Process Change Notice #1602082

PCN Date: 2/8/2016		Effective Date: 5/12/2016	
Title: Marking appearance change for Si7005-B-G/FM			
Originator: GeunJong Baek		Phone: +65 6511 6476	Dept: Supplier Management
Customer Contact: Kathy Haggar		Phone: +1 512 532 5261	Dept: Sales
PCN Type:			
<input type="checkbox"/> Datasheet	<input type="checkbox"/> Foundry	<input type="checkbox"/> Packing	
<input type="checkbox"/> Product Revision	<input checked="" type="checkbox"/> Assembly	<input type="checkbox"/> Labeling	
<input type="checkbox"/> Discontinuance	<input type="checkbox"/> Test	<input type="checkbox"/> Other	
Last Order Date: Not Applicable			
PCN Details

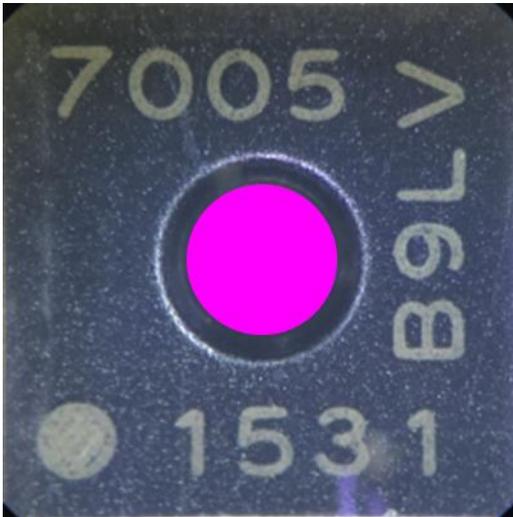
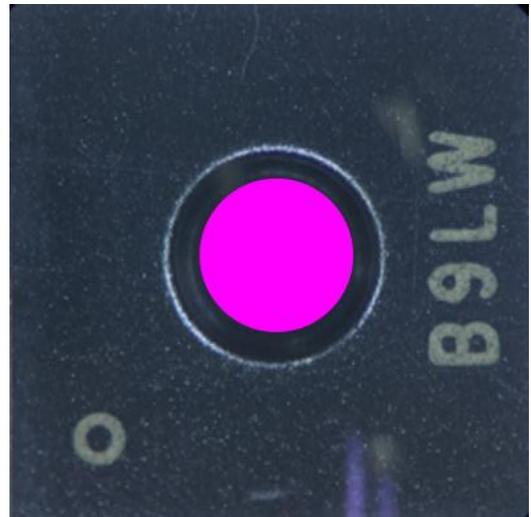
Silicon Labs is pleased to announce marking change on Si7005-B-GM1 product:

Current - Part# + Date code + Trace code

New - Trace code only

Assembly process improvement to minimize marking debris in open sensor area.
